CITY OF ALBUQUERQUE

Re: Monterey Place Apartments
2306-2320 Central Avenue SW
Traffic Circulation Layout
Engineer's/Architect's Stamp 02-11-20

Based upon the information provided in your submittal received 02-13-20, the above referenced plan cannot be approved for Building Permit until the following comments are addressed:

C-101

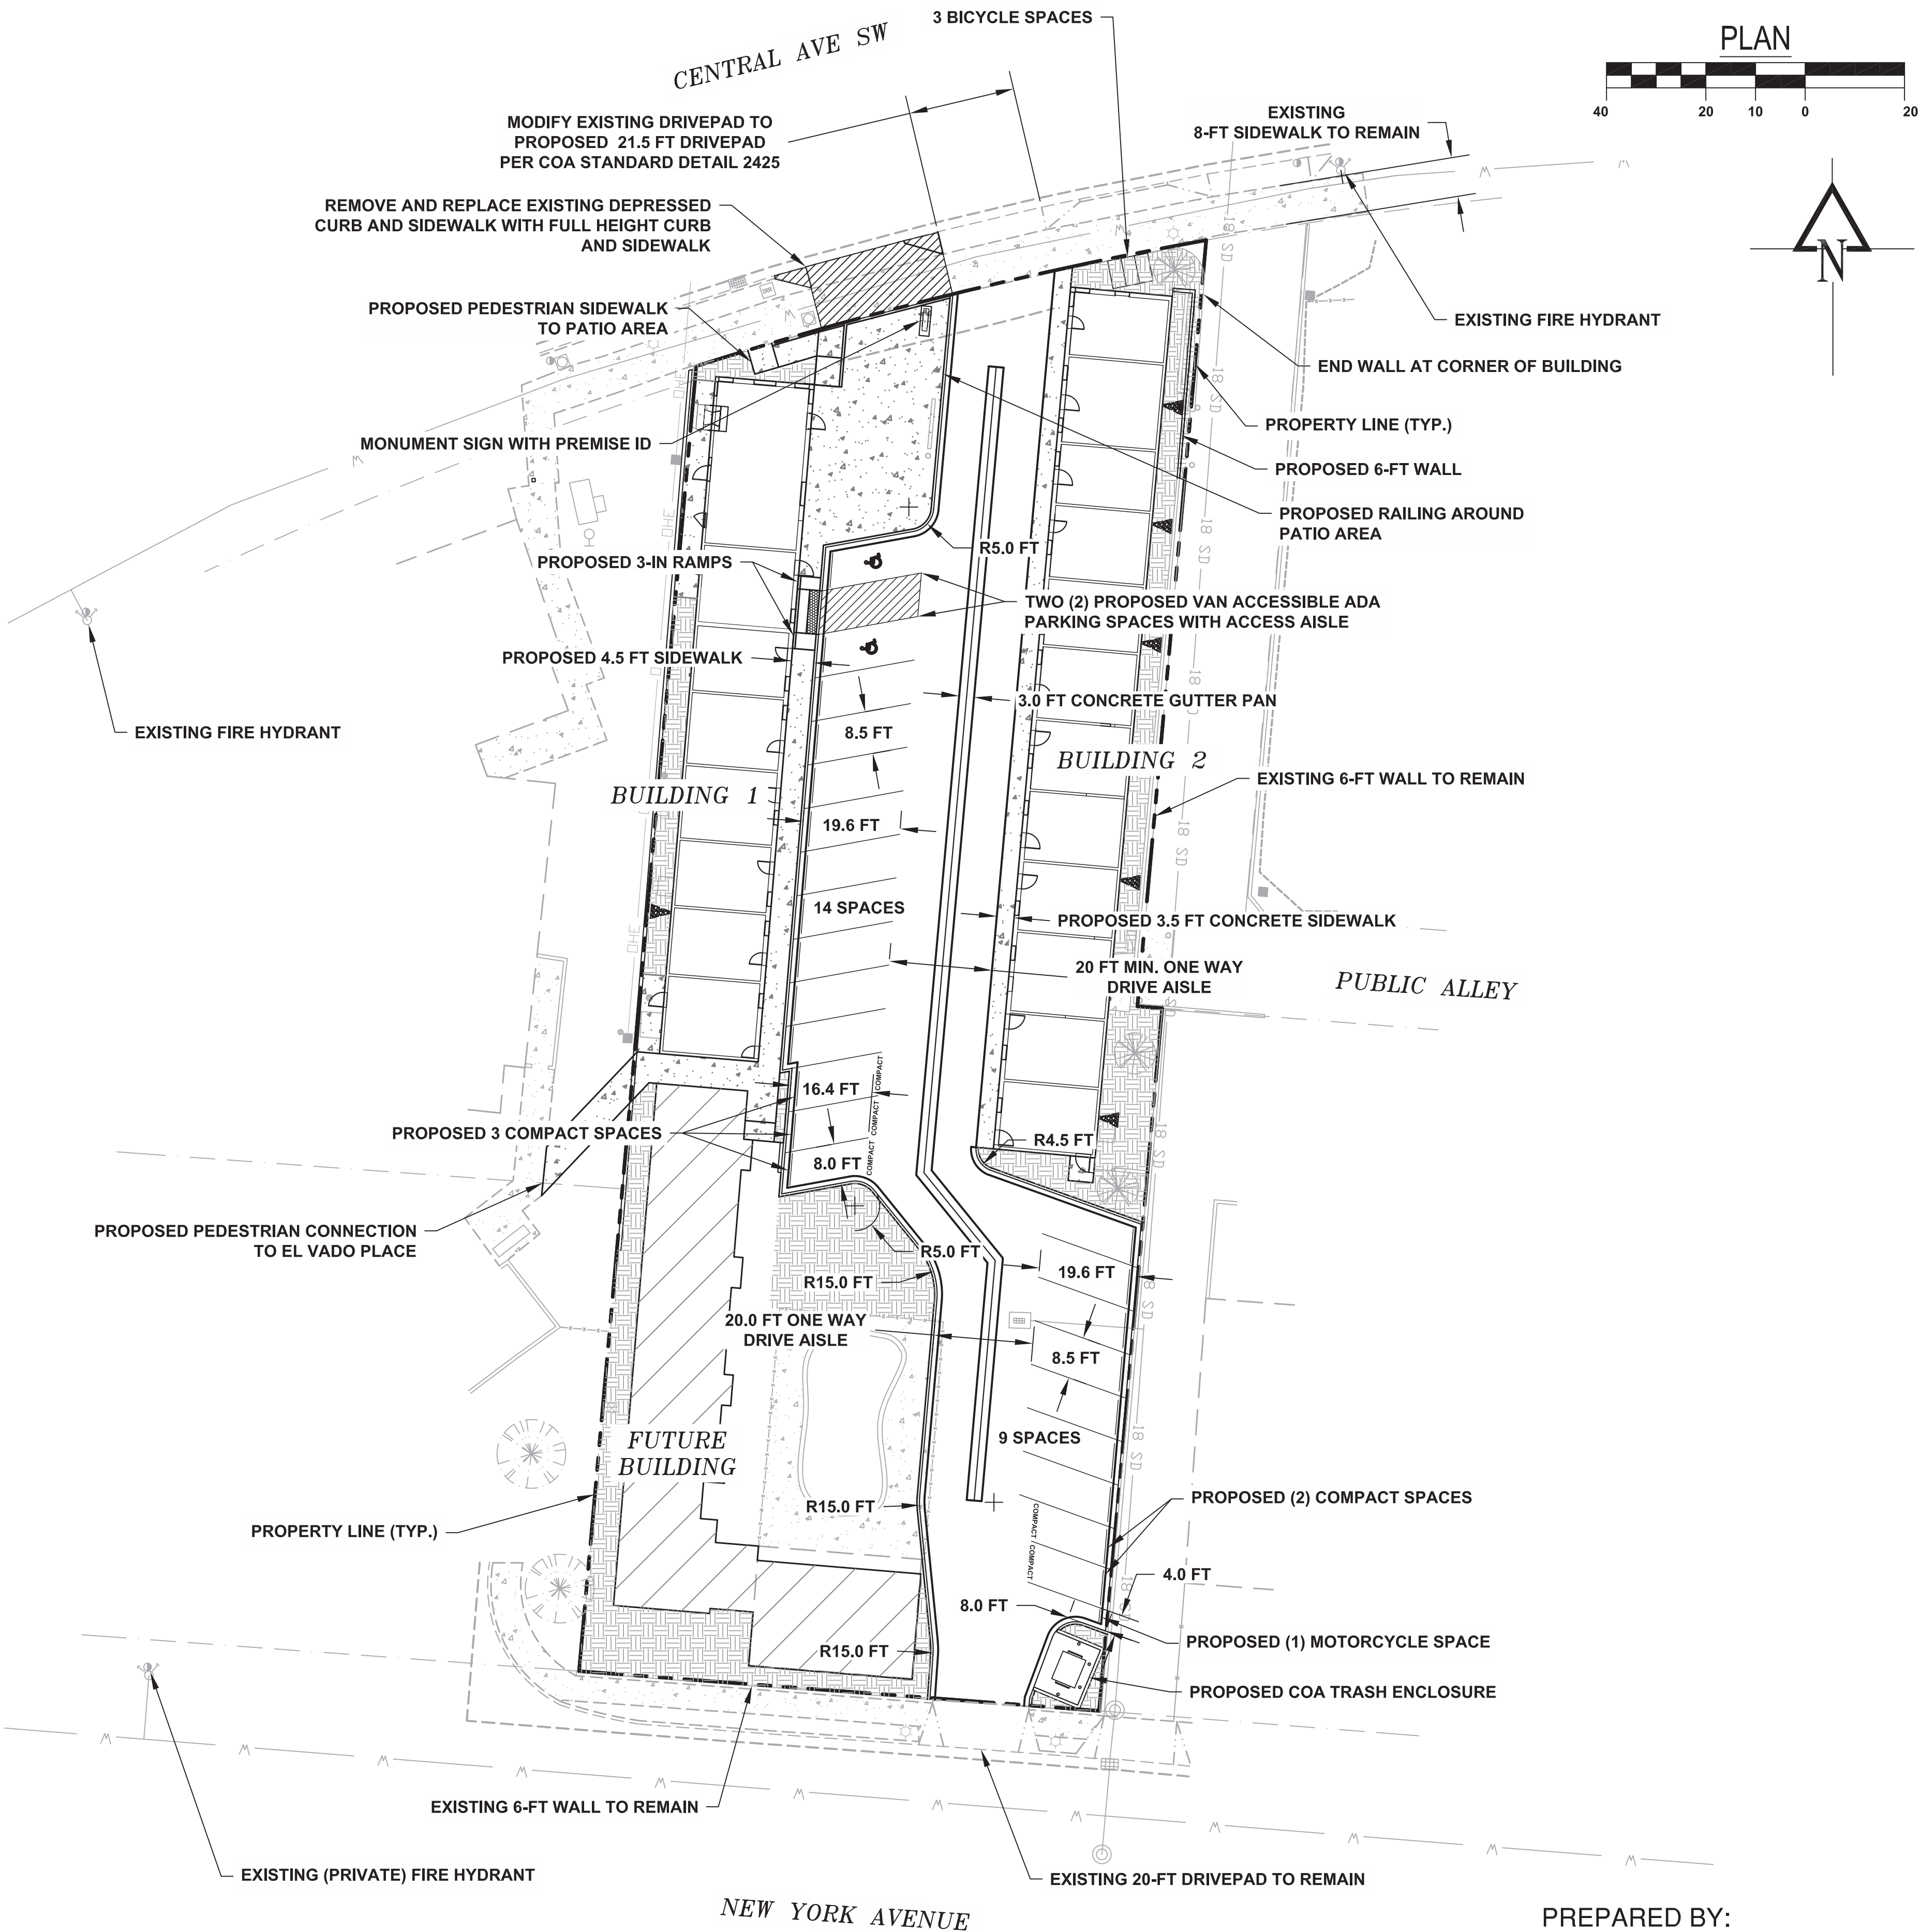
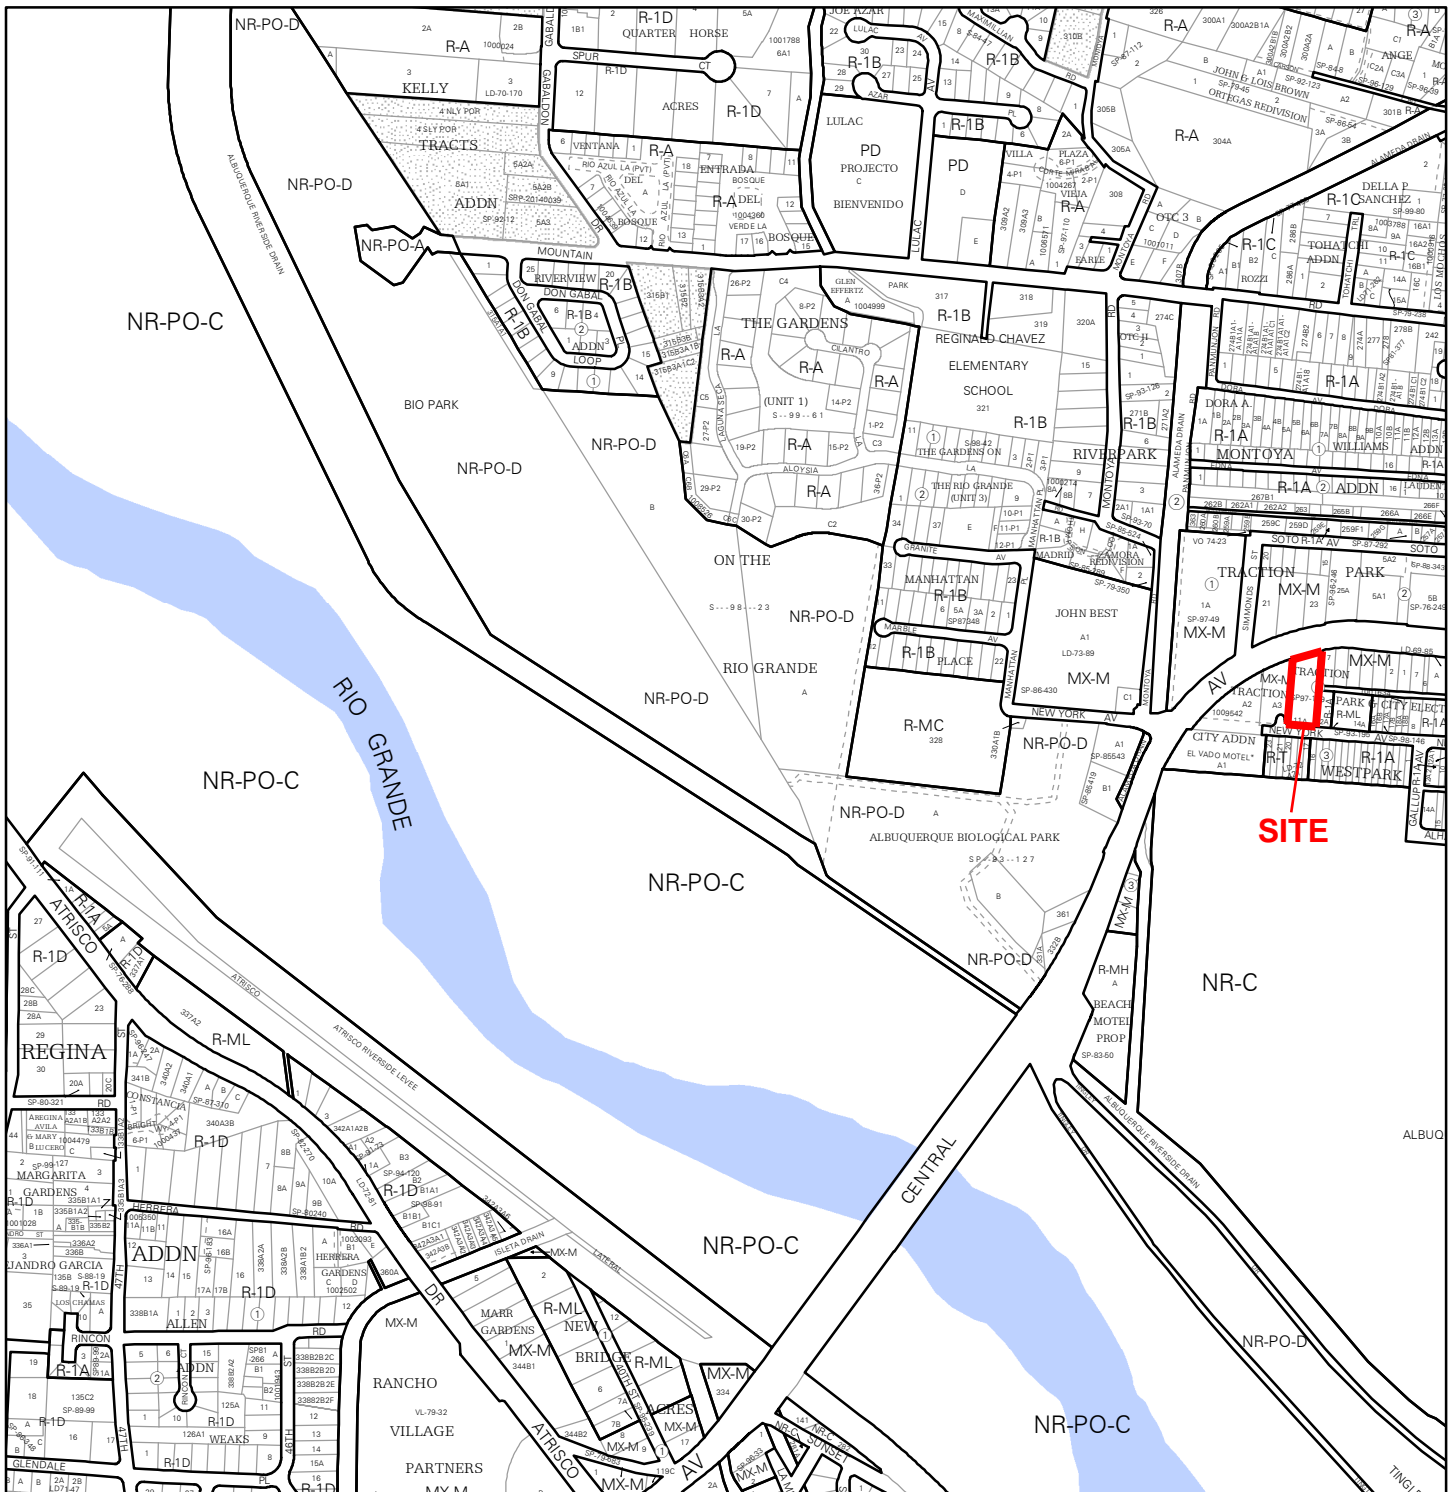
1. Please show a vicinity map showing the location of the development in relation to streets and well known landmarks.
2. Label any existing or proposed easements within the proposed development and access aisles.
3. Proposed number of parking spaces including bicycle and motorcycle parking need to be coordinated with Zoning to ensure compliance.
4. Please list the width and length for all proposed parking spaces. Some dimensions are not shown and provide landscaping buffer between curbing and sidewalk.
5. All proposed/existing entrance widths need to be shown on plans.
6. The minimum parking stall dimensions are:

7. The ADA accessible spaces must include an access aisle. Van accessible aisles should be 8ft wide; all others should be 5ft wide.

8. The ADA accessible parking sign must have the required language per 66-7-352.4C NMSA 1978 **"Violators Are Subject to a Fine and/or Towing."** Please call out detail and location of signs.

9. The ADA access aisles shall have the words **"NO PARKING"** in capital letters, each of which shall be at least one foot high and at least two inches wide, placed at the rear of the parking space so as to be close to where an adjacent vehicle's rear tire would be placed. (66-1-4.1.B NMSA 1978).

10. The sidewalk width abutting the ADA ramp transitions must be the same of the sidewalk to avoid any hazard problems.
11. Provide ADA curb ramps detail which must be the updated to current standards.

12. A detail of the water feature with ADA access crossings needs to be provided.
13. Motorcycle parking spaces shall be designated by its own conspicuously posted upright sign, either free-standing or wall mounted per the zoning code. Label MC on pavement of each space.

14. All bicycle racks shall be designed according to the following guidelines:
 - a. The rack shall be a minimum 30 inches tall and 18 inches wide.
 - b. The bicycle frame shall be supported horizontally at two or more places. Comb/toaster racks are not allowed.

- c. The rack shall be designed to support the bicycle in an upright position. See the IDO for additional information.
 - d. The rack allows varying bicycle frame sizes and styles to be attached.

- e. The user is not required to lift the bicycle onto the bicycle rack.
 - f. Each bicycle parking space is accessible without moving another bicycle.

15. Bicycle racks shall be sturdy and anchored to a concrete pad. Show location of the bicycle racks.
16. A 1-foot clear zone around the bicycle parking stall shall be provided.

17. Bicycle parking spaces shall be at least 6 feet long and 2 feet wide.
18. Per the IDO, a 6 ft. wide ADA accessible pedestrian pathway is required from the public sidewalk to the building entrances. Please clearly show this pathway and provide details.

19. Per DPM, a 6 ft. wide ADA accessible pedestrian pathway is required from the ADA parking stall access aisles to the building entrances. Please clearly show this pathway and provide details.

20. Provide 8 ft. wide sidewalk when stalls are overhanging sidewalk. A solution would be to show parking bumpers on the south side parking stall.

21. ADA accessible pedestrian pathway should not be placed behind parking space or adjacent to a vehicular way. Vehicle and pedestrian/wheel chair conflicts should be avoided as much as possible.

22. Curbing should be installed to delineate landscape, parking, and pedestrian ways and identify points of access. Please provide detail of curb around parking area and end section detail connecting onto public sidewalk.

23. The refuse vehicle shall not back into the public right of way.; provide a copy of refuse approval.
24. It is not apparent what type of pavement surface is being proposed. A hard driving surface will be required as part of this proposed project for parking area and drive aisles.

25. Please specify the City Standard Drawing Number when applicable.
26. Shared Site acces: driveways that straddle property lines, or are entirely on one propertybut are to be used by another property, shall have an access easement. Please include a copy of your shared access agreement with the adjacent property owner.

27. Provide notes showing what work is included and on the work order and the private work on site.
28. Work within the public right of way requires a work order with DRC approved plans. Please provide Work Order, DRB numbers.

29. Please add a note on the plan stating "All improvements located in the Right of Way must be included on the work order."
30. Unused curb cuts must be replaced with sidewalk and curb & gutter. A build note must be provided referring to the appropriate City Standard drawing.

31. Add a note stating "All broken or cracked sidewalk must be replaced with sidewalk and curb & gutter." A build note must be provided referring to the appropriate City Standard drawing.
